MEMORANDUM DATE: July 16, 2026

RE: **Ordinance 2026-04: Consideration of an ordinance to update the City's 10-Year Water Supply Facilities Work Plan pursuant to Section 163.3177 (6) (c) of Florida Statutes**

Previous Service Map

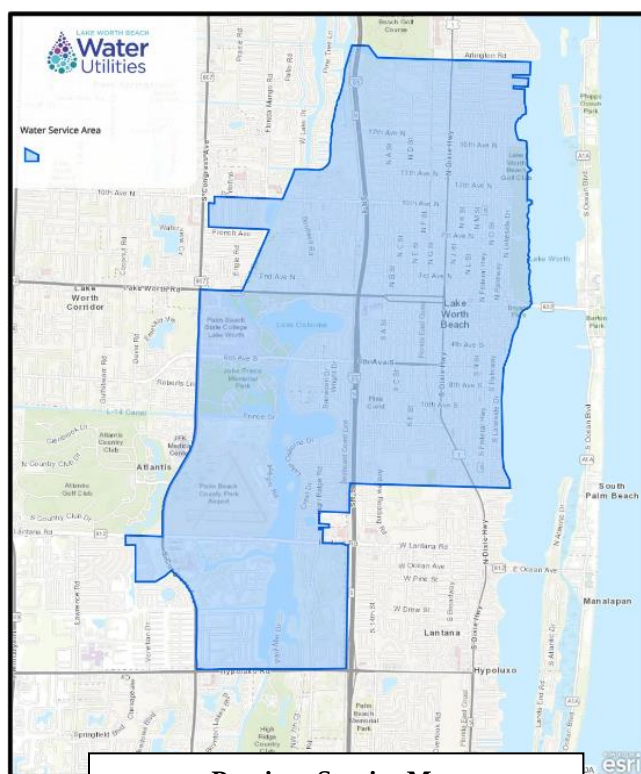
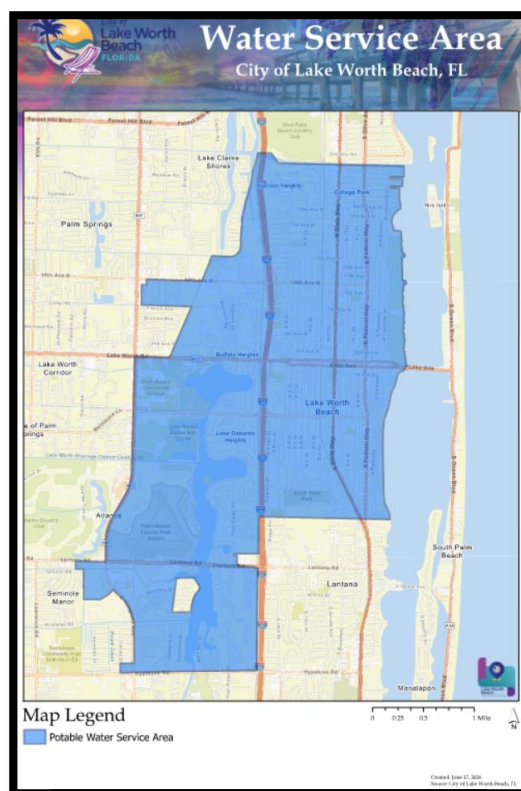
- “The Lake Worth Beach Service Area map (Figure 2-1) is missing an area west of Congress and North of Hypoluxo when compared to the areas served map in the current 2024 Lower East Coast Water Supply Plan Update (LEC Plan). In addition, one neighborhood at the intersection of Donnelly Dr and Boyd Ln on Lake

Osborne is shown as being served by your utility but is not shown as served by the utility in the LEC Plan. Please verify the areas served and update the figure if needed.”

- Lake Worth Beach Service Area Map has been updated to include the previously omitted area located west of Congress Avenue and north of Hypoluxo Road that was not reflected in the version presented at First Reading.
